H89-Z37 Rework

For Rev 0.2 Boards

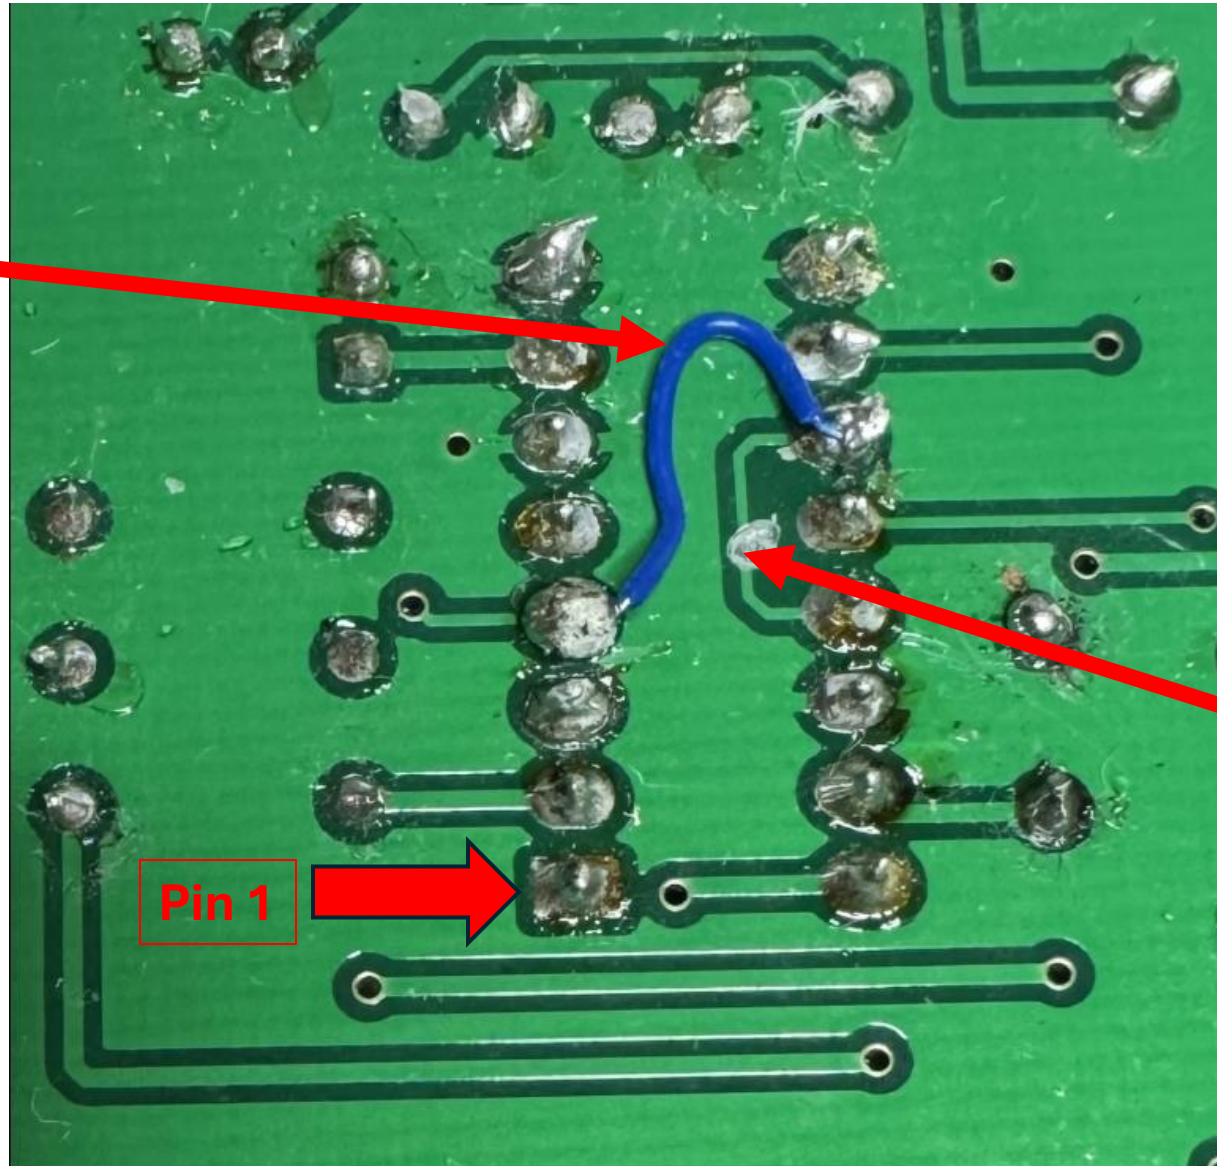
Solder wire between
Pin 4 and pin 11

Cut trace between
Pin 11 and pin 13.
